Product Change Notification / NTDO-29TVUD658

CCB 4623 Final Notice: Qualification of STA as an additional assembly site for LAN9220, LAN9221, LAN9500 and USB2524 SMSC device families available in 56L VQFN (8x8x0.9mm) package

**CCB 4623**  
**Pre and Post Change Summary**  
**PCN #NTDO-29TVUD658**

# Lead frame Comparison

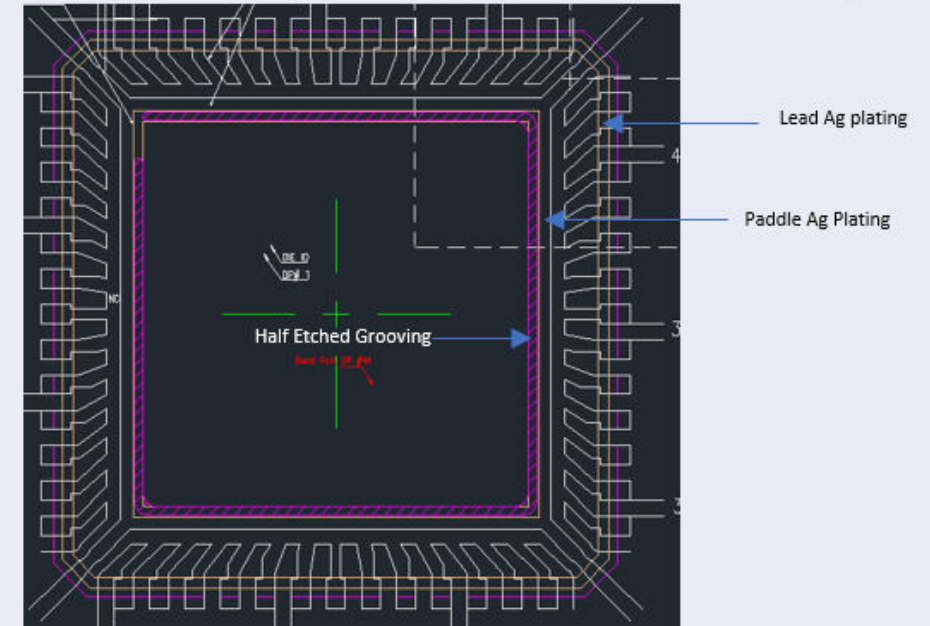
### LF Definition – Double Ring Plating

\*Plating on Lead finger and plating surrounding LF Paddle (Purple shaded area)

### LF Definition – Double Ring Plating

\*Plating on Lead finger and plating surrounding LF Paddle (Yellow outline area)
